**Response to Submissions – New Maitland Hospital (Concept Proposal and Stage 1)  
Metford Avenue, Metford (SSI 9022)**

## **ATTACHMENT A: KEY ISSUES**

**Figure 1 – Modelled Water Supply Connection Points**

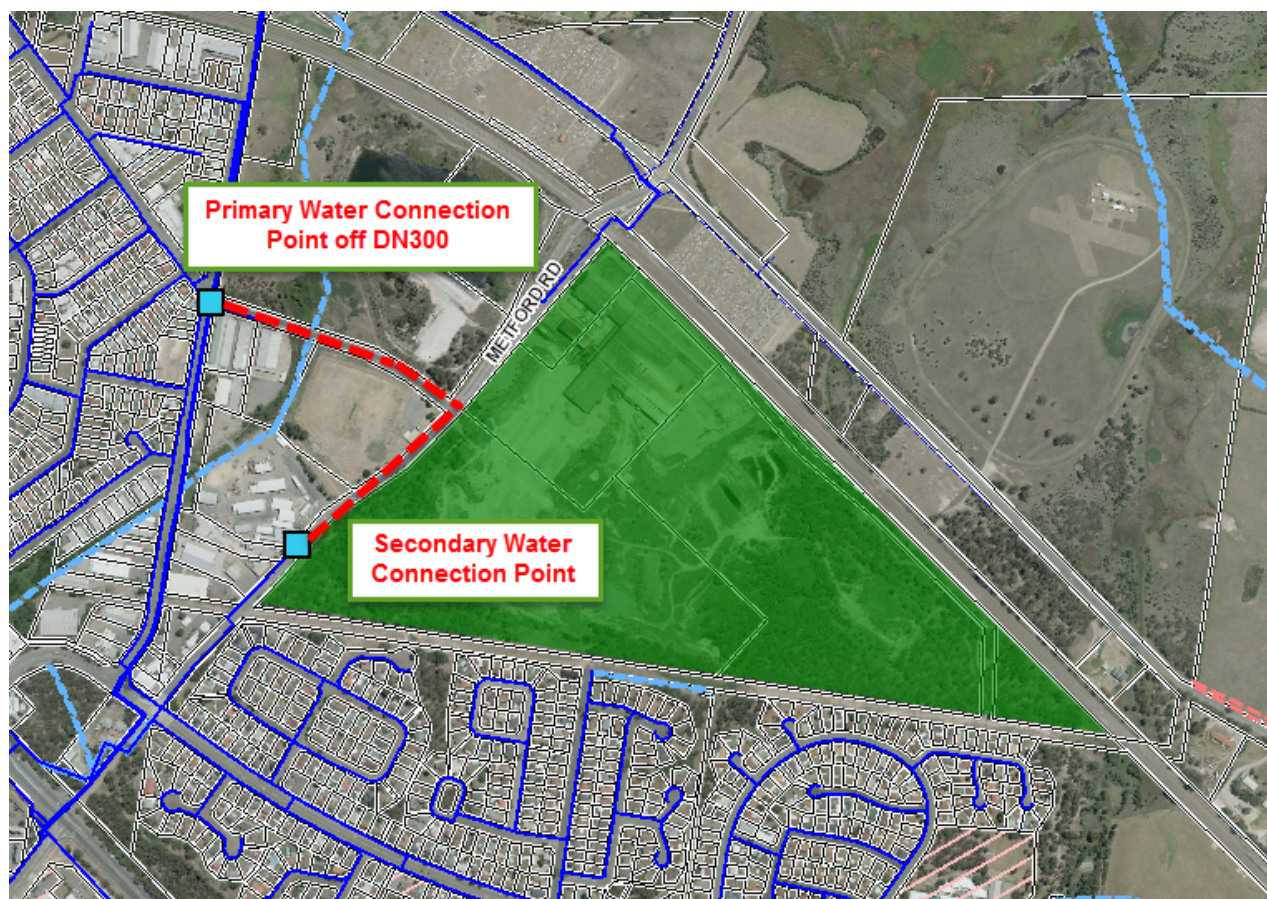
For a primary point of connection, the developer should extend a DN250 water main from the DN300 PVC-M water main in Turton Street along Fieldsend Street to ensure the property has frontage. To provide security of supply, the developer is also required to extend a DN150 water main along Metford Road and cross connect with the proposed DN250 extension from Primary connection point as shown in Figure 1.

**Figure 2 – Assessed sewer point of connection**

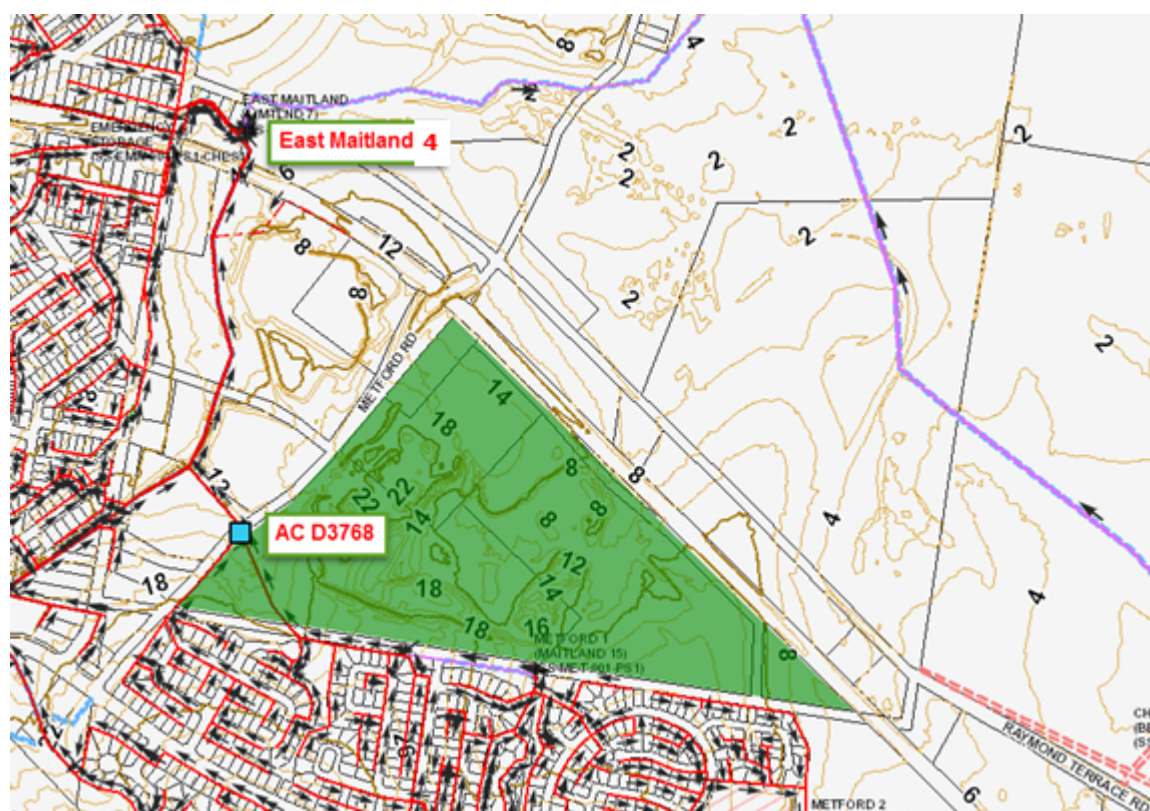
The site of the proposed development is located in the East Maitland 4 WWPS (previously Maitland 7) catchment area. The nearest sewer connection point to service this development is at AC D3768 (Invert 10.38m), located at the western boundary as shown in Figure 2. Pumping may be required to access this connection point. If pumping is required, a servicing report will be required. Please discuss options with Hunter Water before commencing the servicing report.

*Traffic Management Plan for Metford Road.*

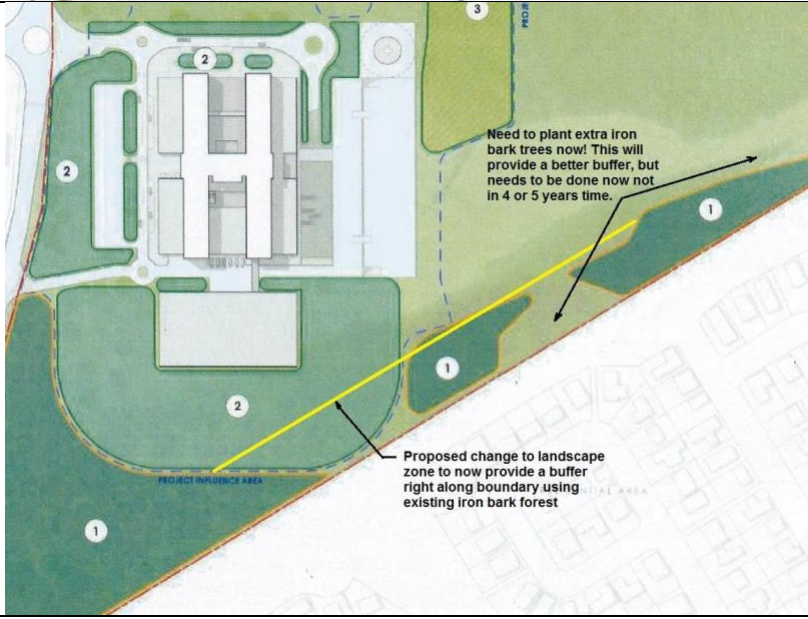
In relation to your traffic data where many areas are predicted to have a fail (F) level of service by 2032, if you conducted you're testing at peak times now and not on an average you would find the system is currently failing. It is nothing to spend 8 to 10 minutes exiting Chelmsford Drive roundabout at 8.30 AM or 3.00 PM and this is without the New Maitland Hospital being open. I suggest the planned new traffic survey in July and August 2018 will show the traffic flow problems are worse than expected.

I note that the proposed corrective action is to modify the two existing roundabouts by increasing the east to south side to two lanes on the Chelmsford Drive roundabout and the addition of several extra 50 metre approach and departure lanes on both the Chelmsford and Raymond Terrace road roundabouts.

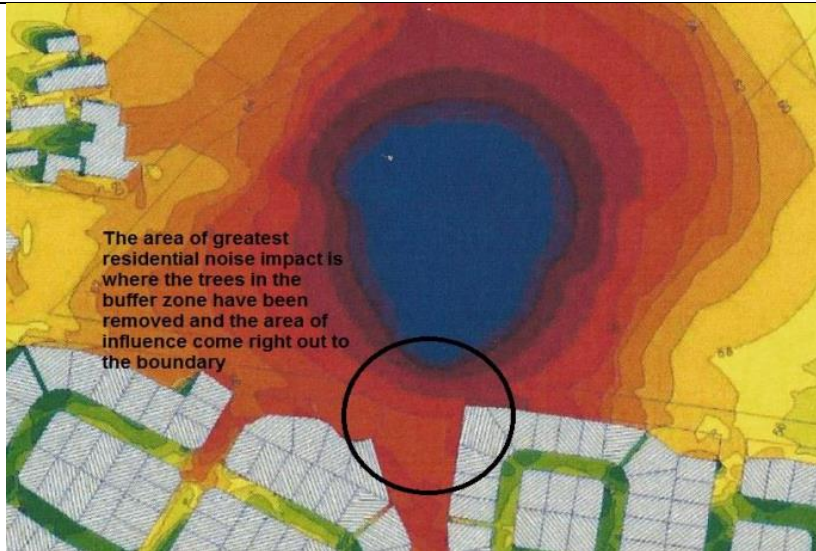
| GU |  <p>Area of Influence taken right out to boundary. Where is buffer zone? Why doesn't it go right across?</p> <p><b>LEGEND</b></p> <ul style="list-style-type: none"> <li>Project Boundary</li> <li>Area of Influence</li> <li>Asset Protection Zone (APZ)</li> <li>Landscape Connectivity Link</li> <li>Proposed buildings</li> </ul> <p>1:2,500</p> |
|    |  <p>Need to plant extra iron bark trees now! This will provide a better buffer, but needs to be done now not in 4 or 5 years time.</p> <p>Proposed change to landscape zone to now provide a buffer right along boundary using existing iron bark forest</p>                                                                                        |
